SERVICE BULLETIN

ENGINE — AIR — RING, SEALING — REPLACEMENT OF, FOR PROCUREMENT

V2500 Series 72-0664

V2500-ENG-72-0664

LOCATION OF THE SEALING RING
75-31-42
FIGURE 1

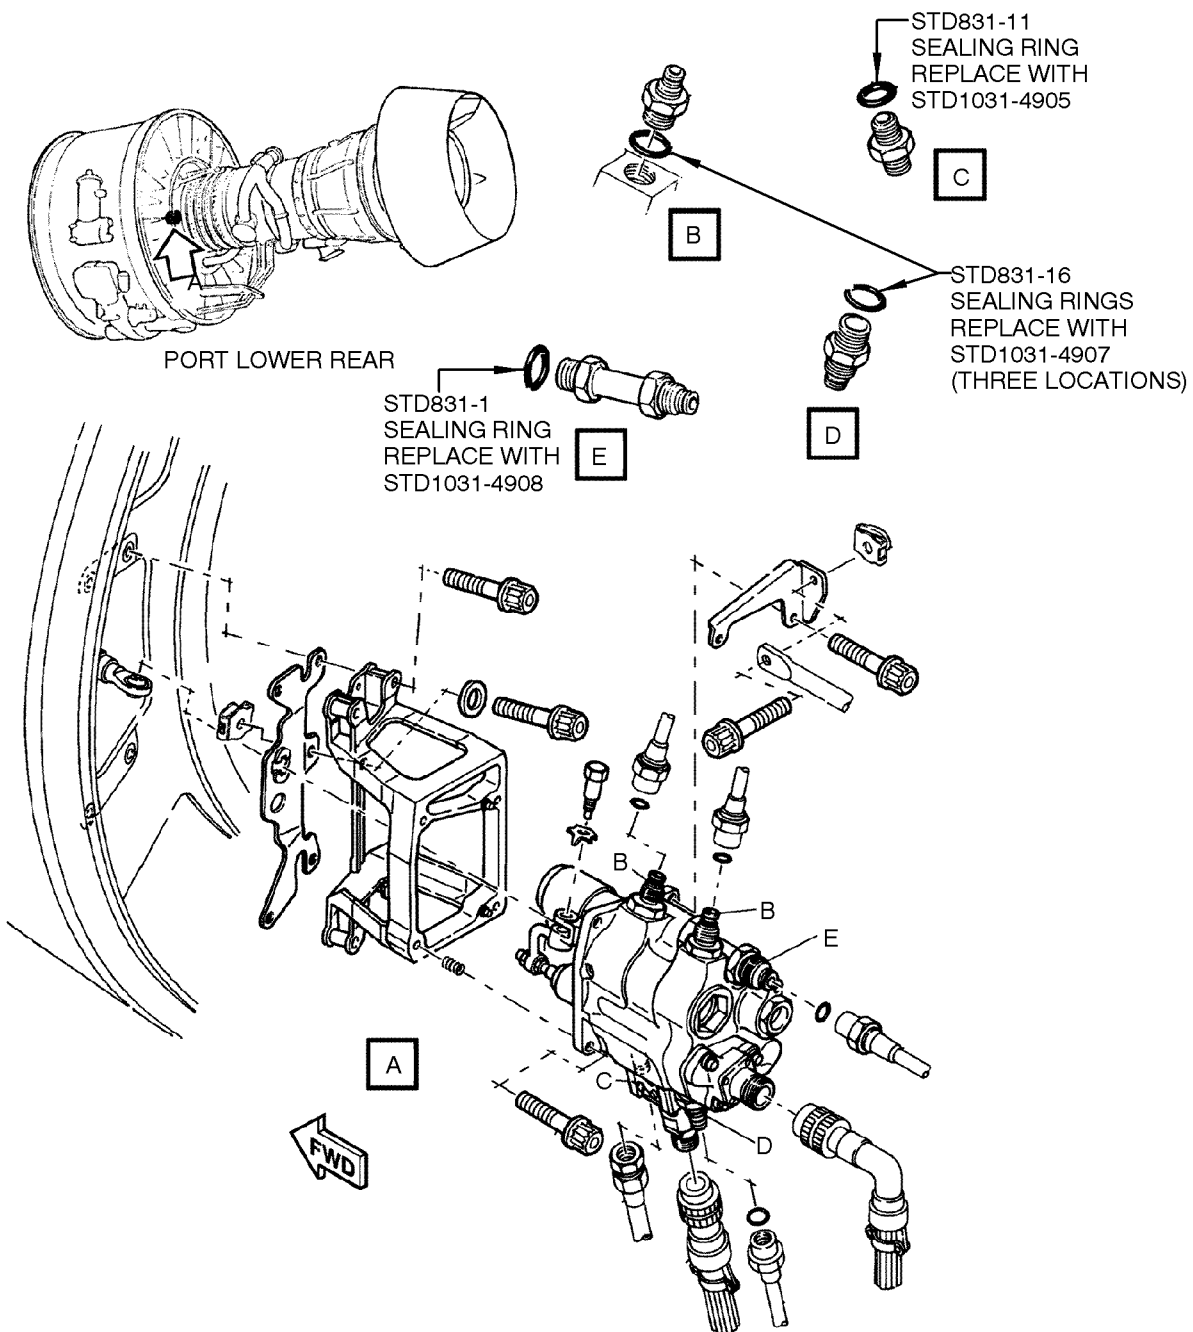
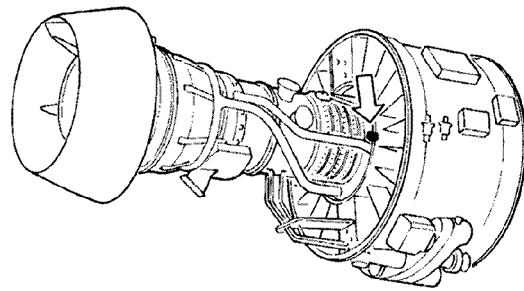
1. Replace the Sealing Ring, PN STD831-1 with PN STD1031-4908, PN STD831-11 with PN STD1031-4905 and three Sealing Rings, PN STD831-16 with PN STD1031-4907. See Figure 1.
2. Replace the Sealing Ring, PN STD831-11 with PN STD1031-4905 and two Sealing Rings, PN STD831-16 with PN STD1031-4907. See Figure 2.
3. Replace the Sealing Ring, PN STD831-16 with PN STD1017-4907. See Figure 3.

LOCATION OF THE SEALING RING
79-23-51
FIGURE 3

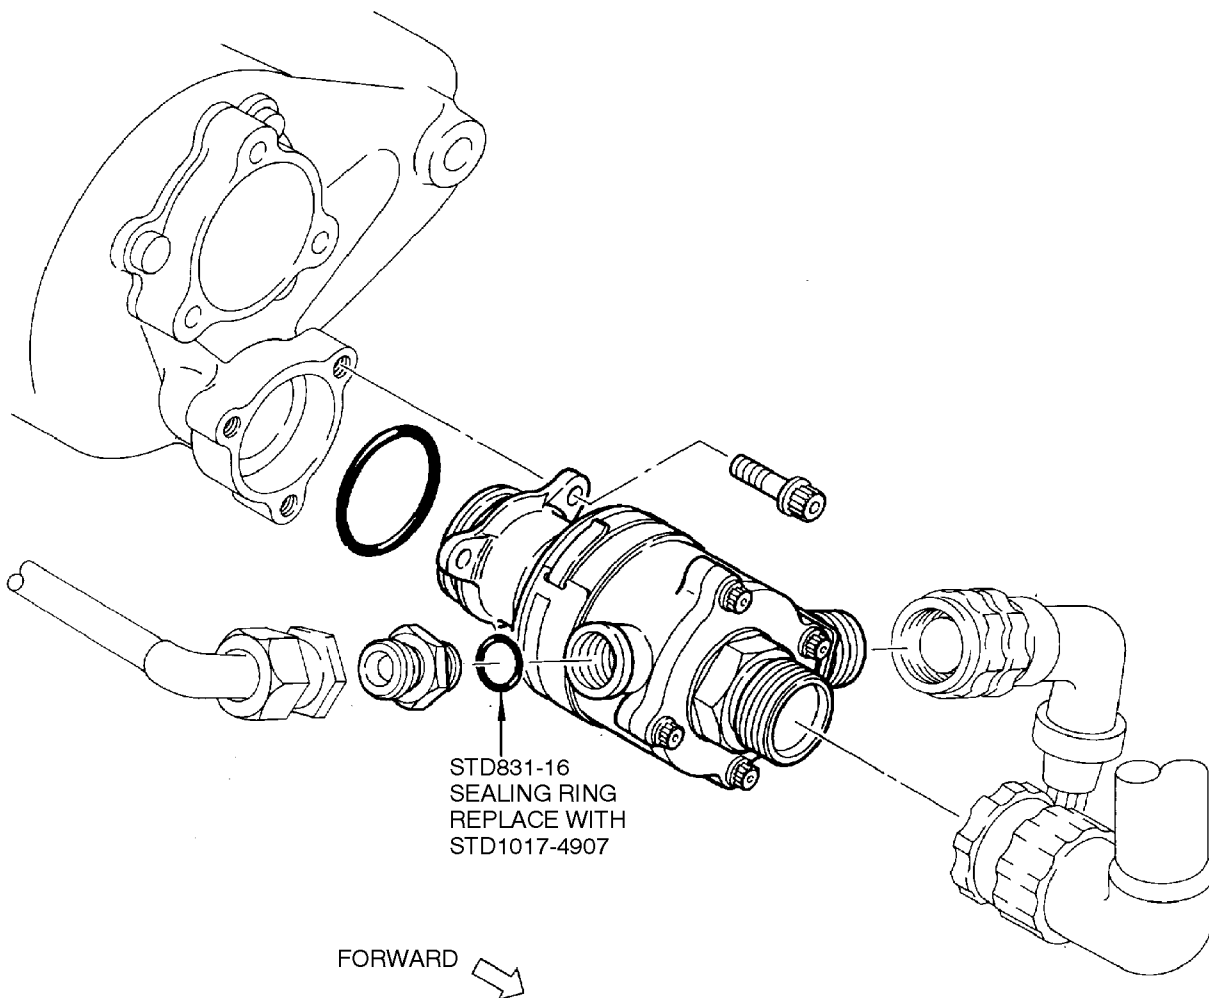
1. Replace the Sealing Ring, PN STD831-16 with PN STD1017-4907. See Figure 3.

LOCATION OF THE SEALING RING
79-23-51
FIGURE 4

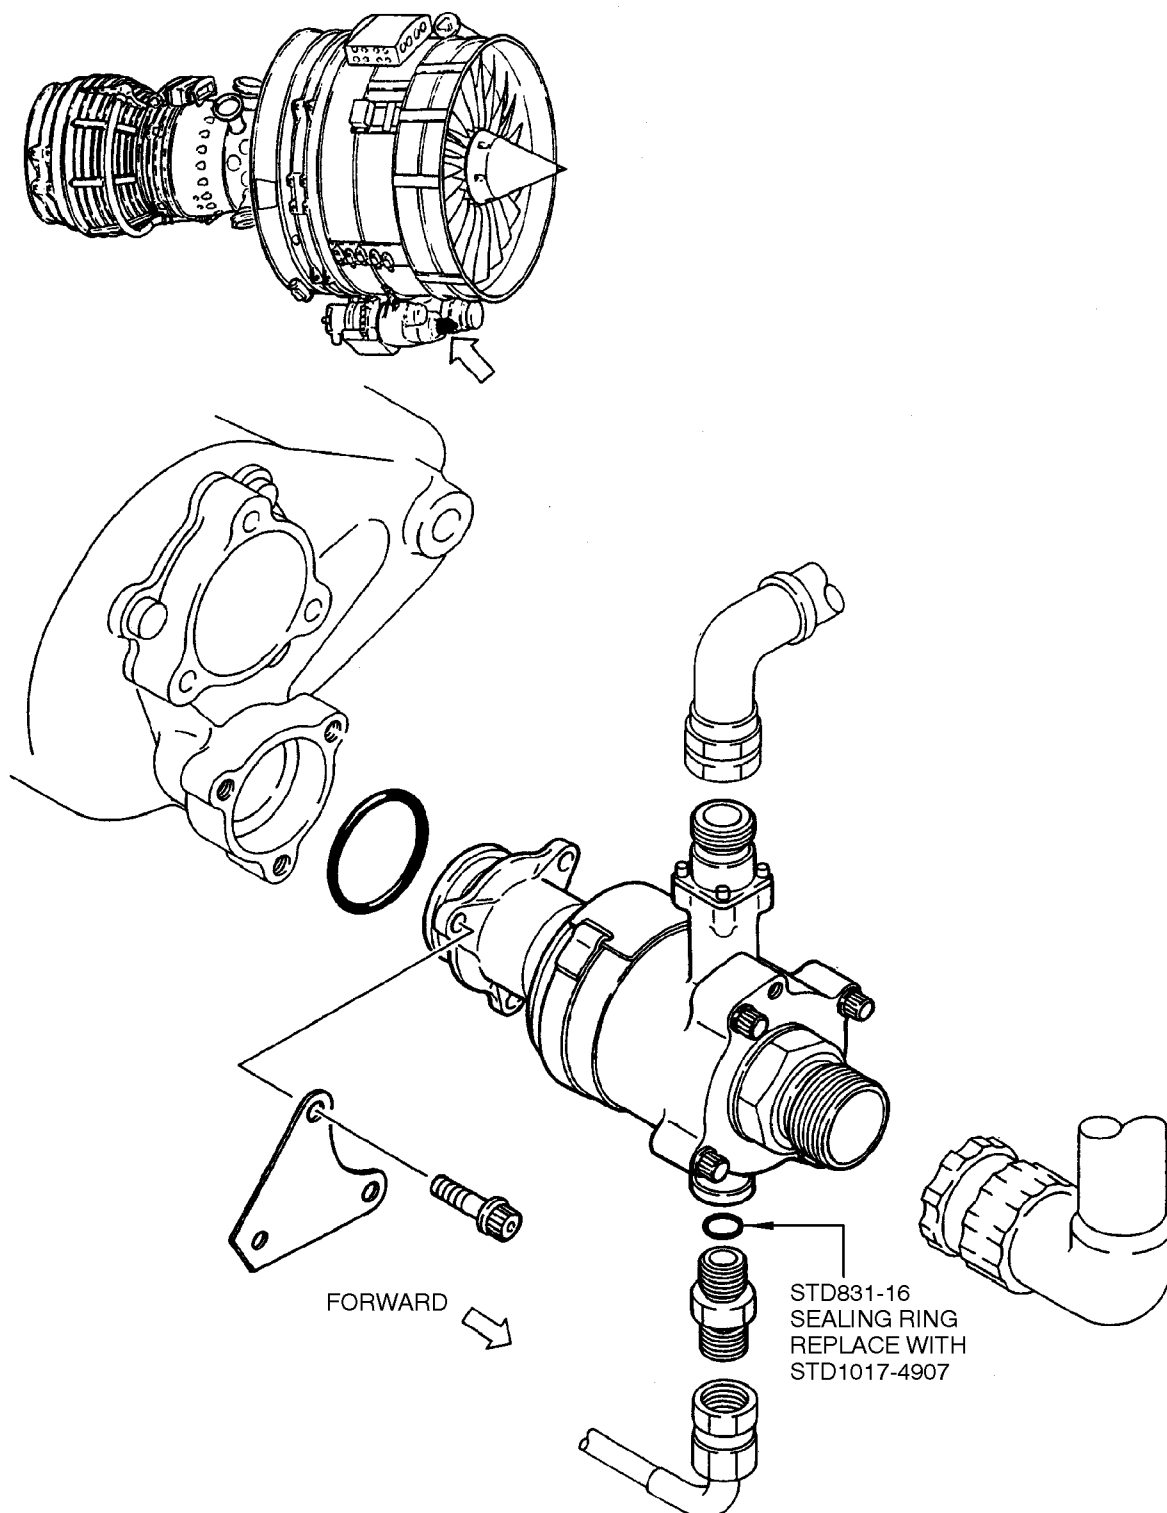
1. Replace the Sealing Ring, PN STD831-16 with PN STD1017-4907. See Figure 4.
